**SOLICITATION AMENDMENT
MODIFICATION DE L'INVITATION**

Title - Sujet Valve components	
Solicitation No. - N° de l'invitation EZ108-202124/A	Amendment No. - N° modif. 004
Client Reference No. - N° de référence du client EZ108-202124	Date 2020-08-12
GETS Reference No. - N° de référence de SEAG PW-\$VIC-260-7981	
File No. - N° de dossier VIC-9-42212 (260)	CCC No./N° CCC - FMS No./N° VME
Solicitation Closes - L'invitation prend fin at - à 02:00 PM on - le 2020-09-01	Time Zone Fuseau horaire Pacific Daylight Saving Time PDT
F.O.B. - F.A.B. Plant-Usine: <input type="checkbox"/> Destination: <input checked="" type="checkbox"/> Other-Autre: <input type="checkbox"/>	
Address Enquiries to: - Adresser toutes questions à: Mountford, Elsie-May	Buyer Id - Id de l'acheteur vic260
Telephone No. - N° de téléphone (236) 464-3238 ()	FAX No. - N° de FAX () -
Destination - of Goods, Services, and Construction: Destination - des biens, services et construction:

SOLICITATION AMENDMENT 004 IS RAISED TO PROVIDE QUESTIONS AND ANSWERS AND MAKE THE FOLLOWING REVISIONS AS FOLLOWS:

Appendix 1, Pump House Modification Layout

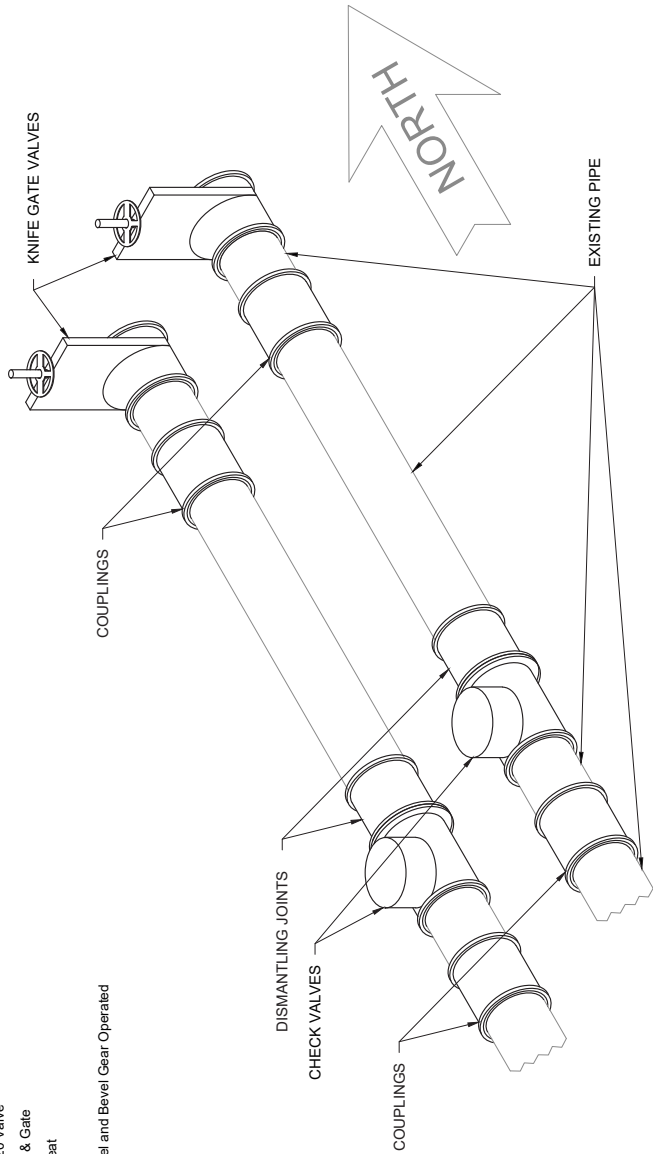
- Answer 8:** Seat Materials have been clarified. (See Requirement part 3.a. and 3.d.)
- Question 9:** Please explain the need behind the drawn assembly (19-107) so I can propose a proper solution.

- Answer 9:** The drawing was provided to indicate the general layout of the desired 4 components. Additional Photographs have now been provided as well. (See Requirement Appendix 1 and Appendix 2.)
